**BOARD OF ADJUSTMENT
CASE REPORT**

Case Number: **BOA-22789**

ZONING CLEARANCE PLAN REVIEW

APPLICATION NO: BLDR-028456-2019 (PLEASE REFERENCE THIS NUMBER WHEN CONTACTING OUR OFFICE)

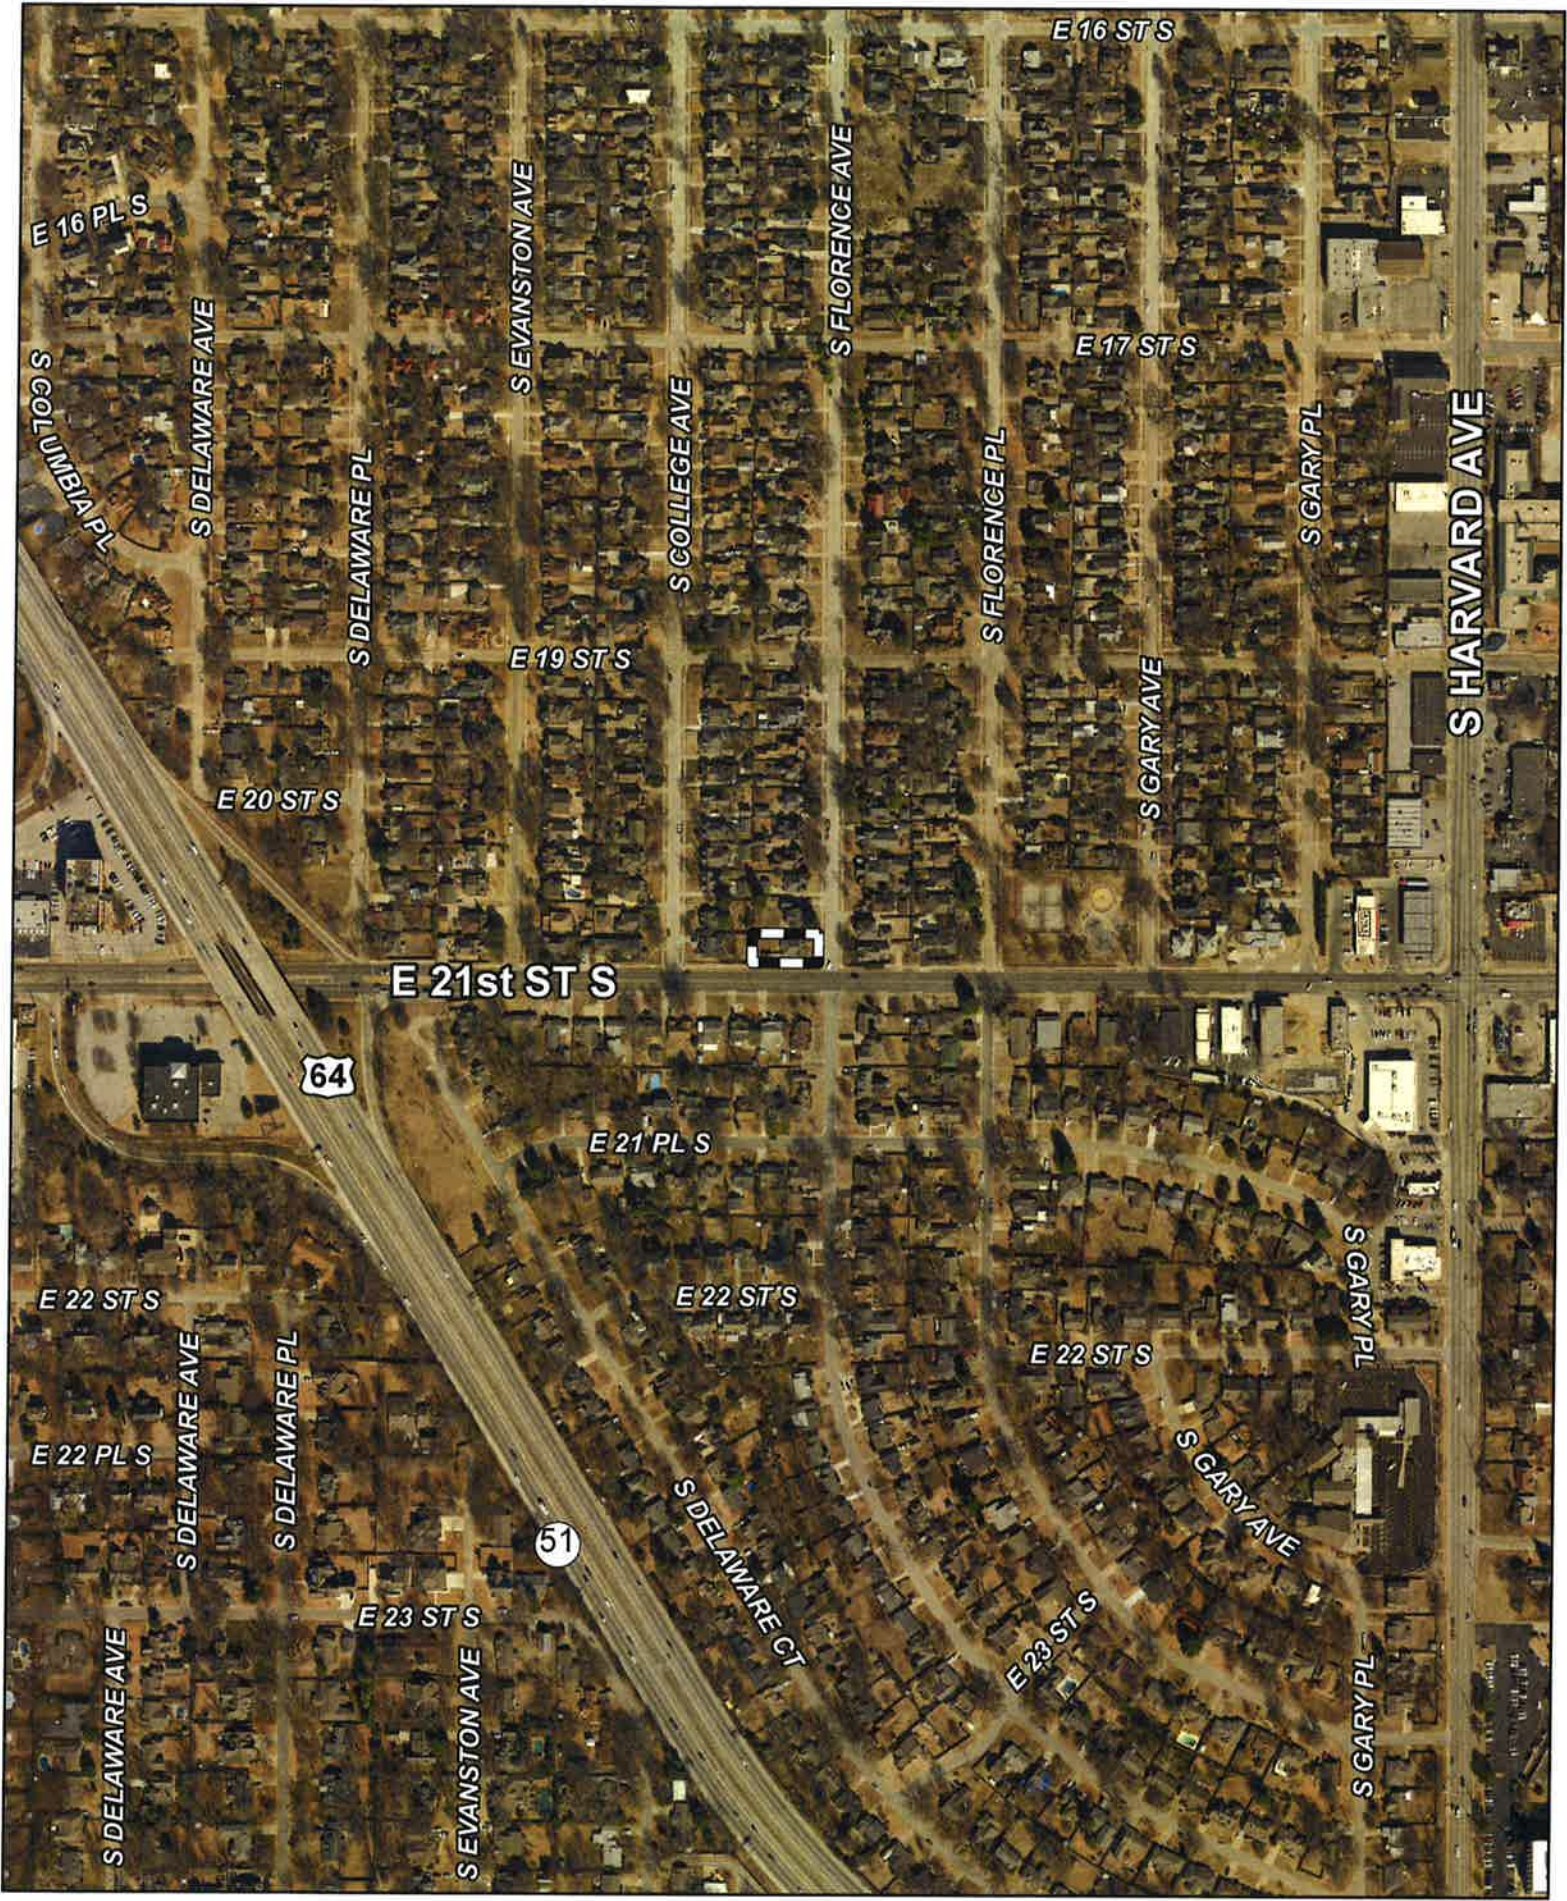
5.030-A :Setback(s) (Residential): In the RS-3 zoned district the minimum side street setback from an arterial street shall be 35 feet from the property line, or measured from the centerline of the abutting arterial street add to the setback distance $\frac{1}{2}$ the right-of-way (ROW) designated on the major street plan.

Review Comments: Revise your plans to indicate a 35' side street setback to the property line and a 85' setback from the center of 21st ROW, or apply to INCOG for a variance to allow less than a 35' side street setback.
